Omaha Public Power District

May 15, 1981

Reference: Docket No. 50-285

The attached information provides before and after sketches of the circuit changes planned for valves PCV-521, HCV-480, HCV-481, HCV-484, HCV-485, and AC sequencer circuit SI-2. A verbal description of the changes to the sequencer circuit and the revisions to EP-35 are also provided.

PCV-521 Before Installation

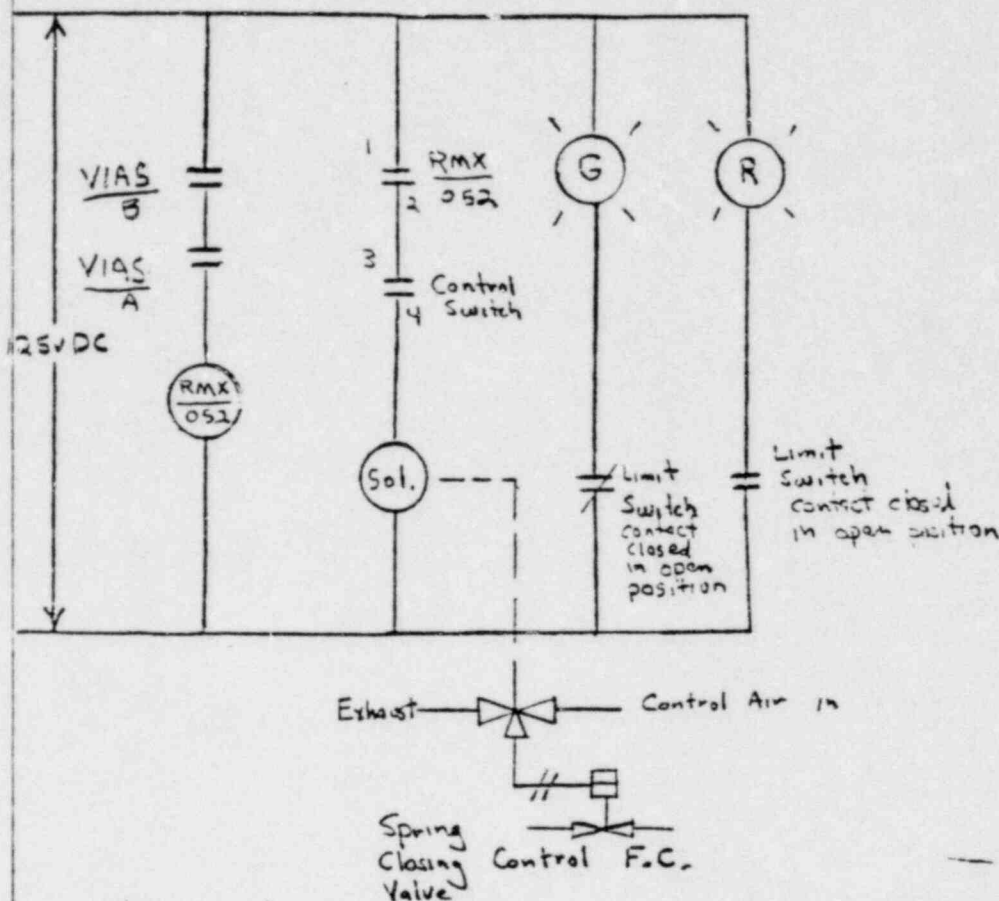
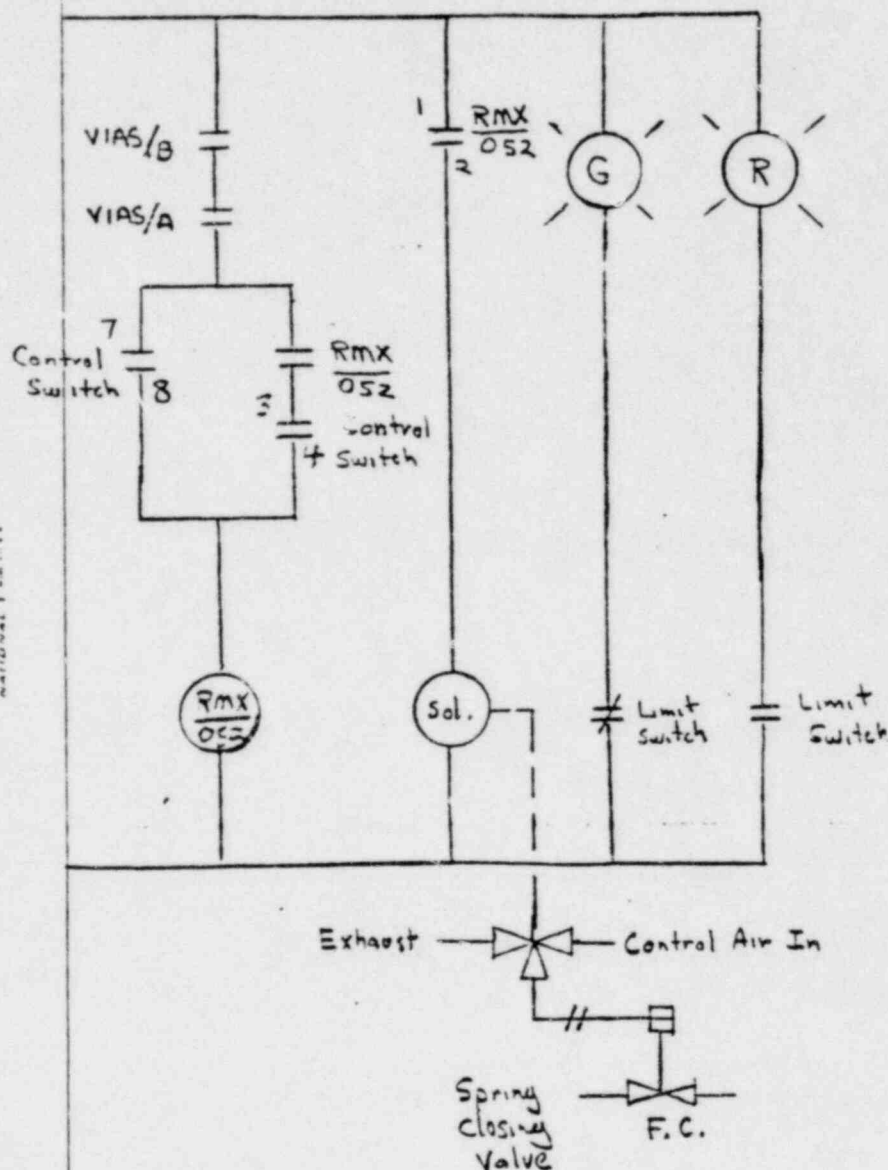
- 1) VIAS - Ventilation Isolation Actuation Signal
- 2) VIAS contacts are closed under normal conditions
- 3) Contacts 3 and 4 are closed in the Control Switch "Open" position. Contact 3 and 4 is a maintained contact.

1. Control Switch has been changed to a spring return to center position switch. Contacts 7 and 8 are closed in the closed position and open in the center position. Contacts 3 and 4 are closed in the closed position and the center position.
2. VIAS - Ventilation Isolation Actuation Signal
3. VIAS contacts are closed under normal conditions
4. Limit switch perform the same as in figure 1

HCV 480, 481, 484 and 485 - override instructions

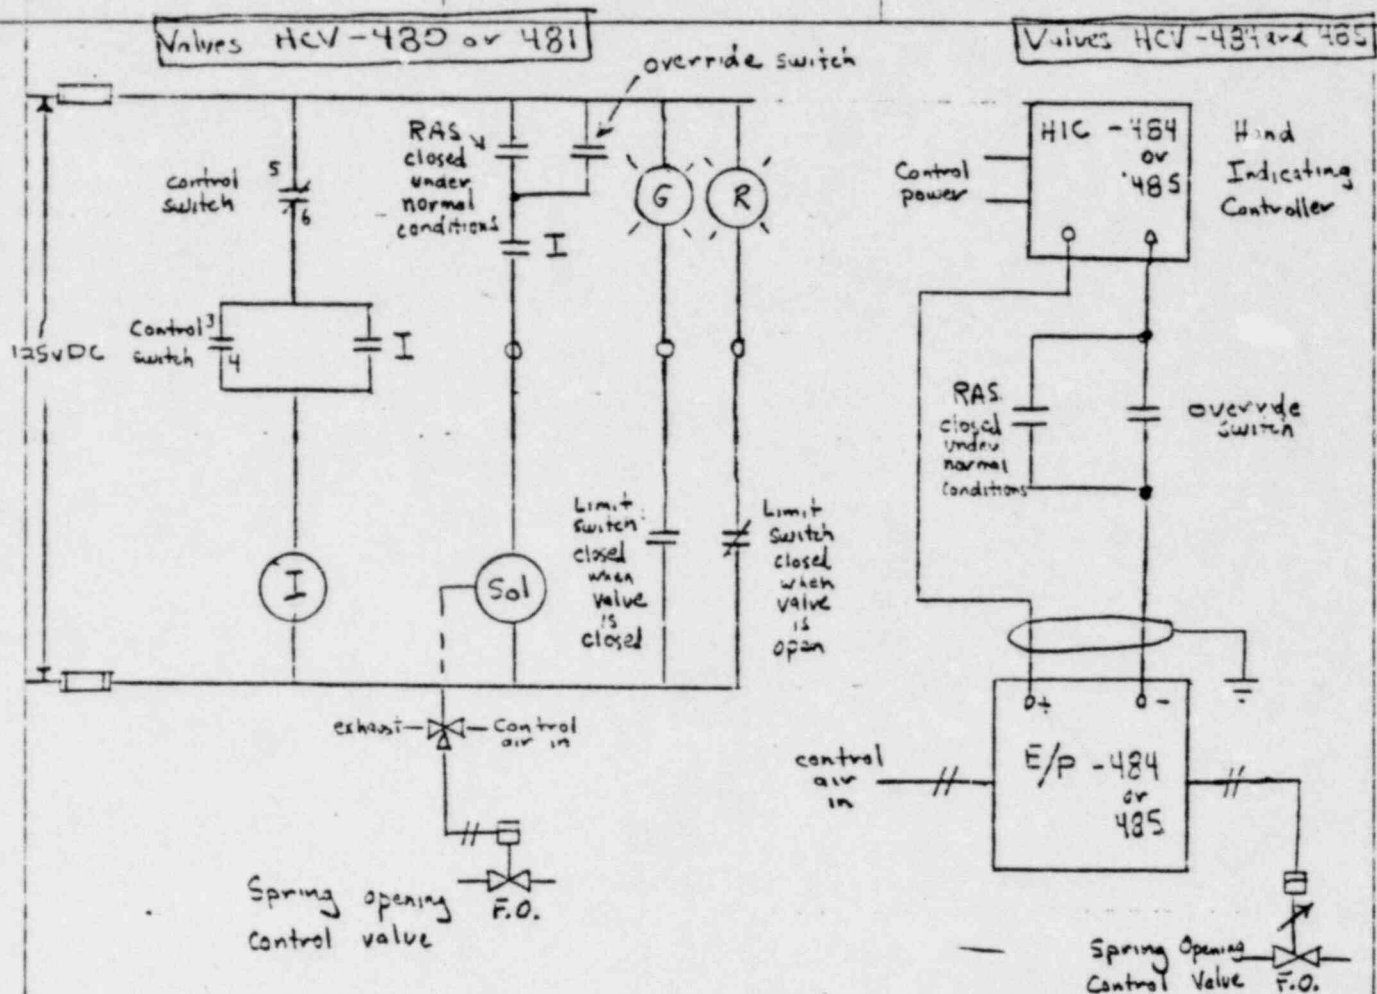
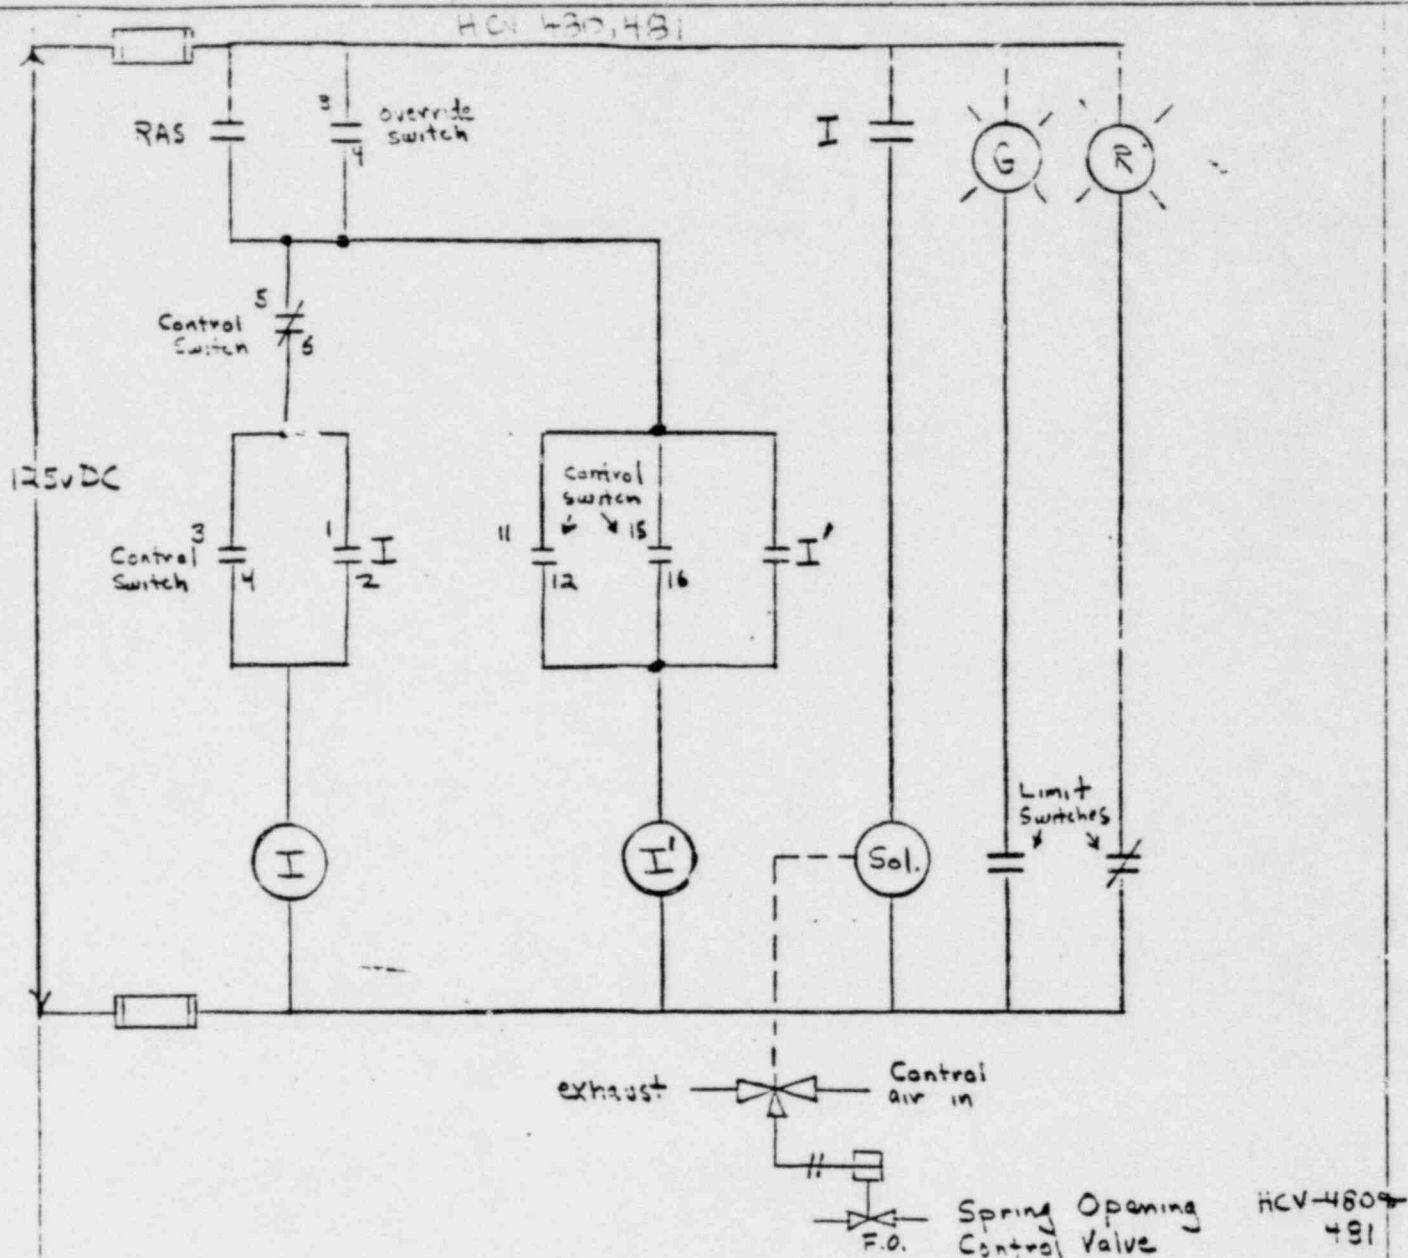
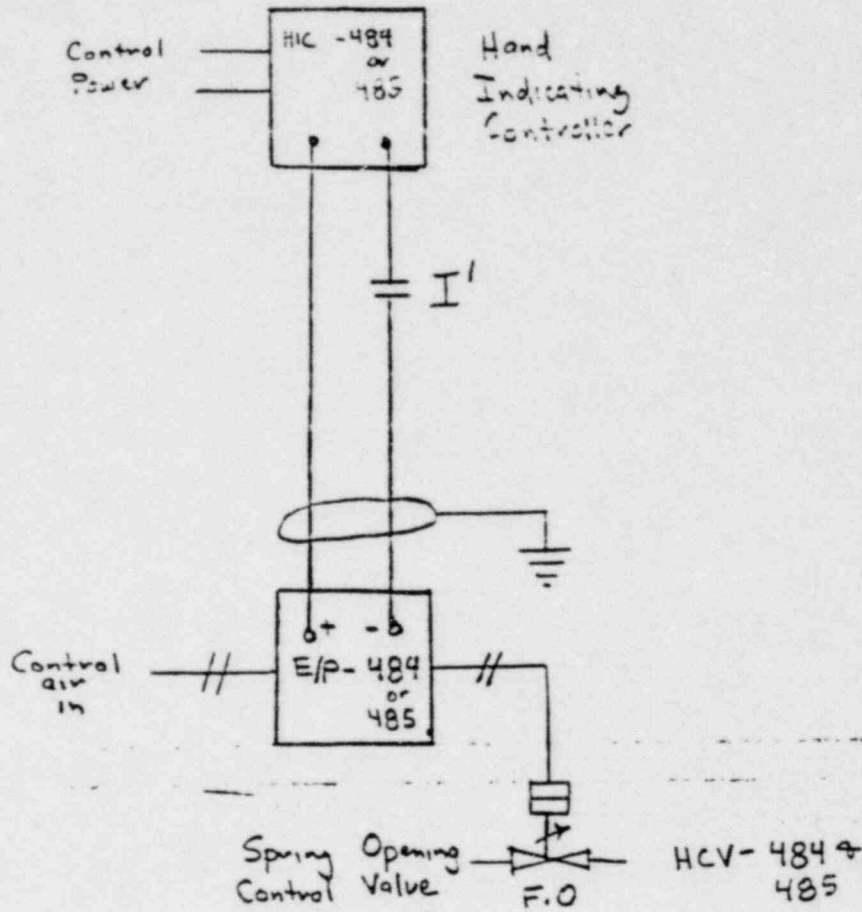
- Notes:
- 1) Contacts 5 and 6 of control switch are closed in the closed position and spring return to normal position
 - 2) contacts 3 and 4 of control switch are momentary and are closed in closed position only
 - 3) The control switch consists of 3 positions - closed, normal and open
 - 4) RAS - Recirculation Activation Signal
 - 5) Override switch operates valve pairs i.e. HCV 480 and 484 ; HCV 481 and 485
 - 6) Valves 484 and 485 go full open upon receipt of RAS. Upon reset of RAS the valves go to the position desired as set by the hand indicating Controller.

- Notes:
- 1) RAS - Recirculation Actuation Signal
 - 2) contacts 5 and 6 of control switch are closed in the closed position and spring return to normal position
 - 3) contacts 3 and 4 and 11 and 12 are momentary and are closed in the closed position only
 - 4) contacts 15 and 16 are momentary and are closed in the open position only
 - 5) RAS contact closed under normal conditions
 - 6) Override switch operates valve pairs i.e. HCV-480 and 484; 481 and 485
 - 7) An additional relay I' will be needed for valves HCV-484 and 485
 - 8) The hand indicating controller controls the position of the valves HCV-484 and 485 when the 10-50 milliamp circuit (Figure 2) is completed. When the contact I' is open the valve(s) go full open.

AC Sequencer Circuit SI-2 Before Modification

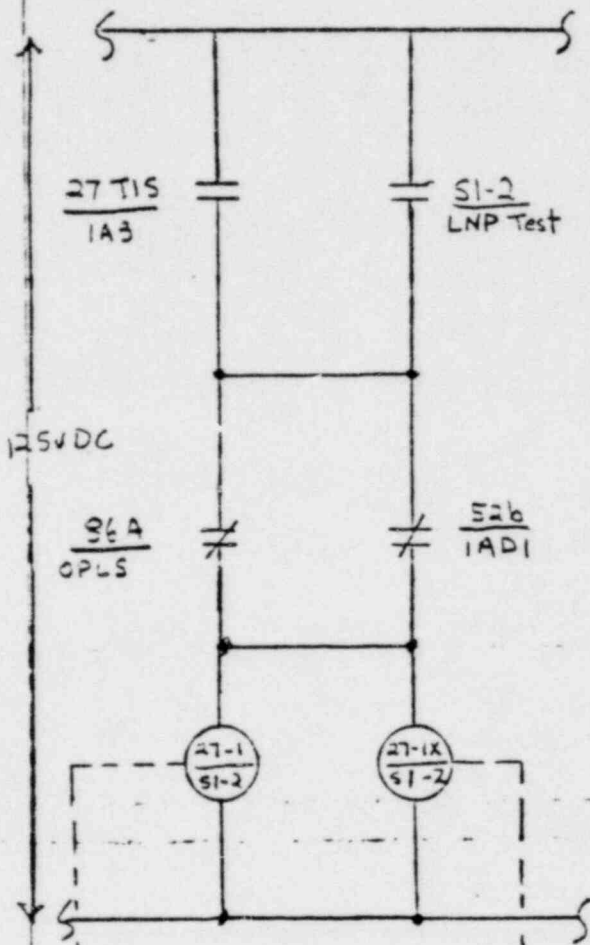
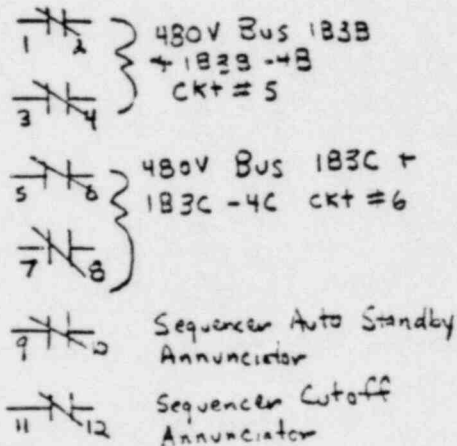
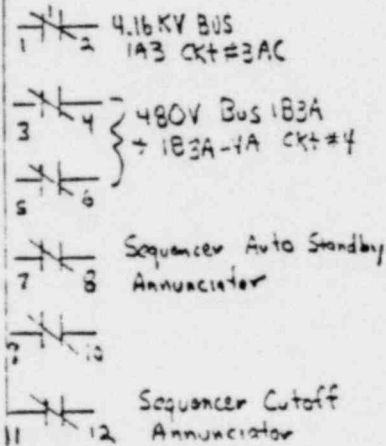
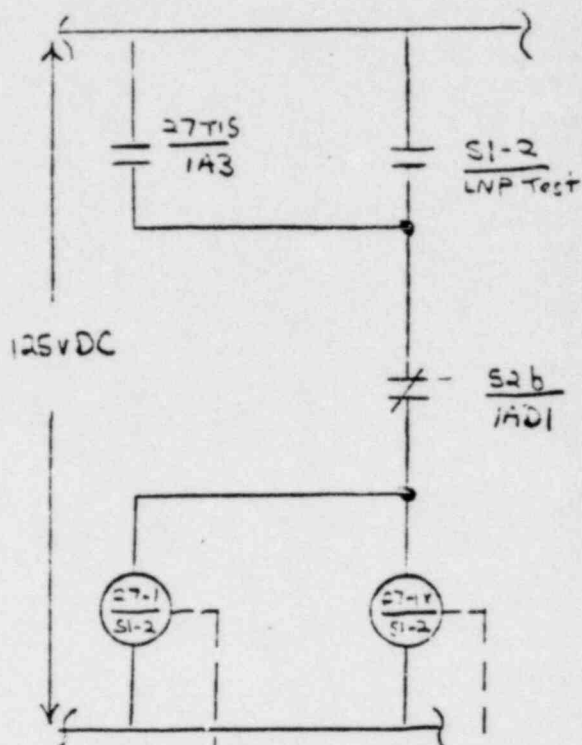
Upon receipt of an Offsite Power Loss Signal (OPLS) the following will happen (refer to Figure 5):

1. Relay 27 TIS/1A3 is energized closing the contact in Figure 5.
2. Contact 86A/OPLS opens.
3. Diesel Generator circuit breaker auxiliary ^{contact 52b/1AD1} remains closed. This contact stays closed until the circuit breaker ~~opens~~ ^{closes}.
4. Relays 27-1/SI-2 and 27-1X/SI-2 are energized. The contact outputs from these relays will reset the sequencer timing relays. This action will load shed the 4160 V safeguard buses thus preparing the buses for the diesel generator.
5. The diesels accelerate up to running speed with the proper voltage established at its terminals. The diesel generator circuit breaker closes and contact 52b/1AD1 opens, thereby de-energizing 27-1/SI-2 and 27-1X/SI-2. The sequencing timers are beginning to time out and safeguard loads begin to be loaded.

1. Assume that the 86A/OPLS lockout is reset before the 86B/OPLS lockout is.
2. Contact 86A/OPLS in Figure 5 will close.
3. Contact 27 TIS/1A3 remains closed as 86B/OPLS keeps the relay 27 TIS/1A3 energized.
4. Relays 27-1/SI-2 and 27-1X/SI-2 are energized. The contact outputs from these relays will reset the sequencer timing relays. This will again loadshed the safeguard buses which is the undesirable feature of this scheme.

Presently, this problem is being addressed administratively in EP-35 for the interim process. Test switches in series with the 86A/OPLS and 86B/OPLS contacts that energize 27 TIS/1A3 relay will be opened prior to the OPLS lockout reset. This will ensure that the 27 TIS/1A3 contact will be opened, thereby eliminating any possibility of picking up relays 27-1/SI-2 and 27-1X/SI-2. As a permanent solution, the District is looking into removing contact 86A/OPLS from the sequencer scheme. The original

intent of contact 86A/OPLS being in this control circuit would be to arm the sequencer circuit while the diesel generator is being tested in its monthly surveillance test. The Architectural Engineering firm of Stone and Webster is employed by the District in preparing a safety analysis for the removal of the OPLS contact. It should be noted that a favorable safety analysis is required before final approval to remove the contact will be made.
